TO: ALL PASSENGER CAR MANUFACTURERS
ALL LIGHT-DUTY/MEDIUM-DUTY VEHICLE MANUFACTURERS
ALL OTHER INTERESTED PARTIES

SUBJECT: ON-BOARD DIAGNOSTICS II (OBD II) REGULATORY REVIEW

Typical PCV System

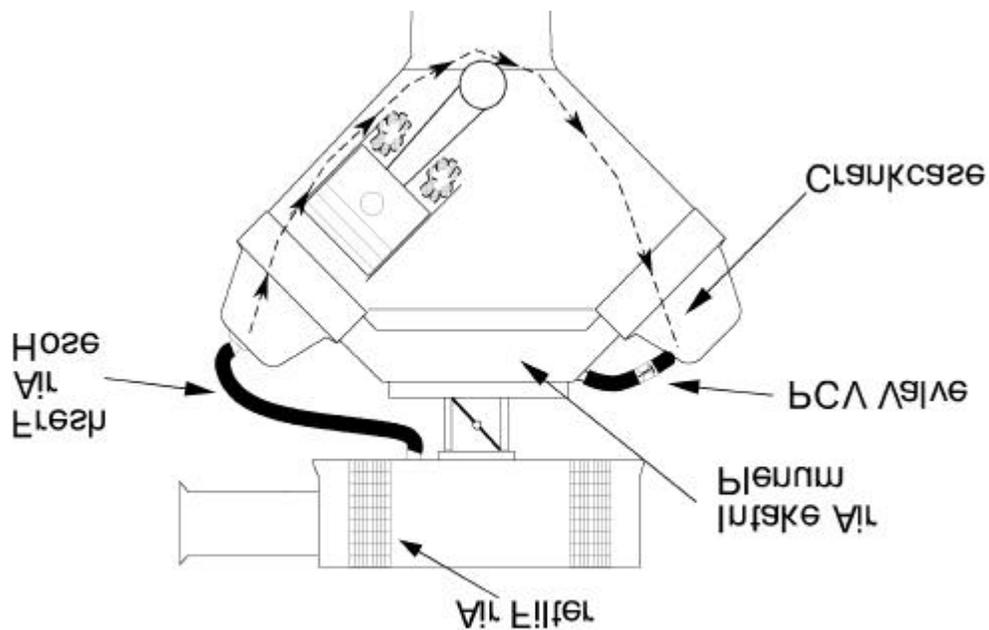
The staff's proposal targets only the failure modes that would most likely result in direct venting of emissions to the atmosphere, namely, disconnection in the system between the crankcase and the intake manifold on the PCV valve side of the system (refer to diagram below). Failure modes of this type are the most likely to cause a substantial increase in emissions (i.e., 1.2 g/mi HC). Other PCV system failure modes include a disconnected fresh air line or a plugged PCV valve but the staff is not recommending that these failure modes require monitoring. This is because disconnection of the fresh air line between the air cleaner and the crankcase may not result in a serious emission problem since most crankcase emissions would still be purged through the PCV valve (an operational PCV valve would cause a negative pressure in the crankcase, resulting in aspirating fresh air through the fresh air line rather than release of crankcase vapors). Further, plugging of the PCV valve will not result in direct venting to the atmosphere unless the fresh air line is also disconnected since pressure build up in the crankcase would likely force vapors through the fresh air line into the air cleaner which would then be inducted into the engine (i.e., this is a closed system). Recognizing the difficulty in detecting a disconnected fresh air line and the limited probability of both malfunctions occurring at the same time, the ARB's proposal would not require detection of this dual component failure.

Accordingly, the regulation would require only the detection of a disconnection in the system between either the crankcase and the PCV valve (crankcase vapors would escape directly through the opening in the crankcase system), or between the PCV valve and the intake manifold (crankcase vapors would exit through the PCV valve outlet). In terms of effectively monitoring for such occurrences, the latter failure mode will result in a significant intake air leak that should be identifiable with the existing monitoring strategies for the idle air control system or the fuel system. The staff's proposal would not require the stored fault code to specifically identify the disconnection, provided service information generated by the manufacturer directs technicians to examine the connection as a possible cause of the fault. On the other hand, a disconnection in the system between the crankcase and the PCV valve would be significantly more difficult to detect with existing monitors, and may require added hardware to verify integrity (e.g., a pressure switch to ensure flow between the crankcase and the PCV valve). However, in order to facilitate compliance, the staff's proposal would exempt manufacturers from detecting disconnection between the crankcase and the PCV valve if the PCV valve is fastened securely and directly to the crankcase or valve cover (e.g., a threaded connection). This is because such disconnections often occur during service operations wherein technicians will likely remove the PCV valve and hose assembly together if the valve is easily removed from the crankcase (normally through a grommet located in a valve cover). If the technician finds disconnection of the PCV hose from the valve itself much easier because the PCV valve is securely fastened, then the most likely event is a hose disconnection rather than a valve disconnection. Failure to reinstall a hose, however, can be readily detected with existing monitoring strategies whereas failure to reinstall the PCV valve may not be as easily detected. Therefore, slip-on PCV connections via grommets, or other quick release designs would not be exempted.

Under the staff's proposal, implementation of this requirement would begin with the 2000 model year, and would be phased-in through the 2002 model year in percentages of 30, 60, and 100, respectively. Small volume manufacturers would be exempt from the phase-in percentages provided full compliance is achieved by the 2002 model year. For most PCV system designs, the valve could be securely fastened to the valve cover or crankcase. Therefore, in order to achieve compliance with this proposed requirement, the manufacturer would only need to ensure that a disconnection between the PCV valve and the intake manifold would be detected. Some manufacturers have indicated that this is already the case on a portion of their models. In any event, the lead time specified would allow manufacturers to make necessary monitoring system changes, and to relocate the PCV valve within the system, if needed. The staff requests comments on its assessment of the changes necessary to meet this requirement and the associated phase-in schedule.
